End Wall Installation Issue

The Issue

2. Swap double and single fins on BR and BL end walls

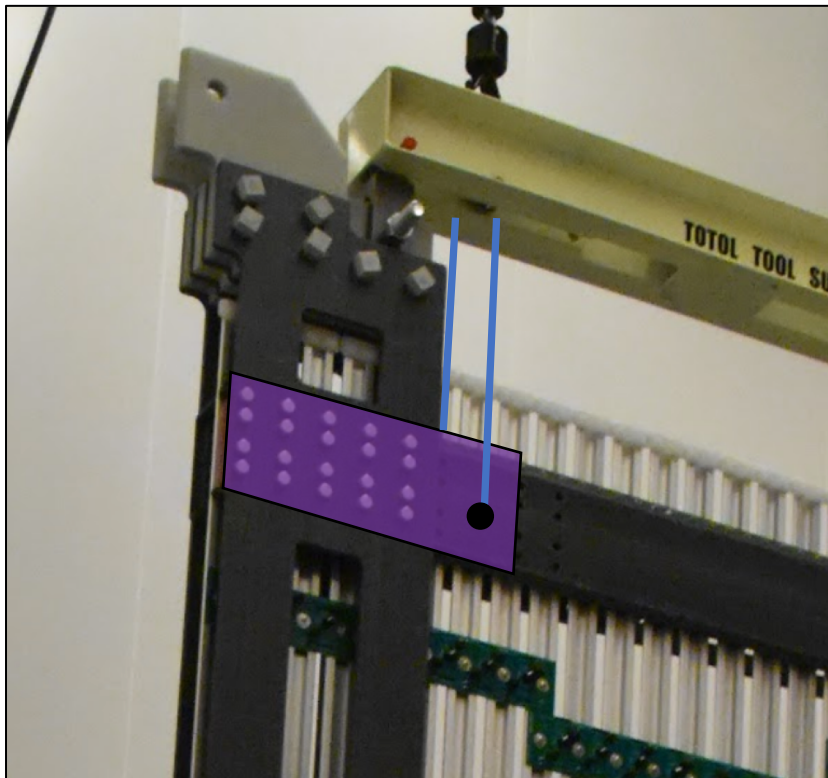
- Requires coming up with a new lifting point on the CPA-side of the end wall (the current is on one of the plate we want to replace)
